33511B-02

Modification Recommended Service Note

33511B Function Generator

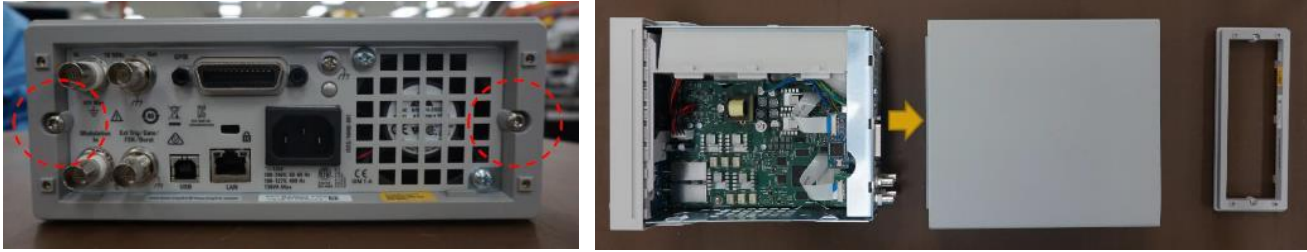
The Problem – Some customers have reported that, when line power is applied to the instrument but the instrument is NOT turned on (“Standby Mode”), some instruments will emit an audible high-pitched whistle or whine. To fix this, the existing power supply must be replaced with a newly designed power supply, as detailed in the solution below.

The solution is to replace the old power supply with a new one. The old power supply was manufactured by XP Power. The new power supply is manufactured by MeanWell, and has Part Number 0950-6082.

Old Noisy XP Power Supply (PN xxxx-xxxx)

New MeanWell Power Supply (PN 0950-6082)
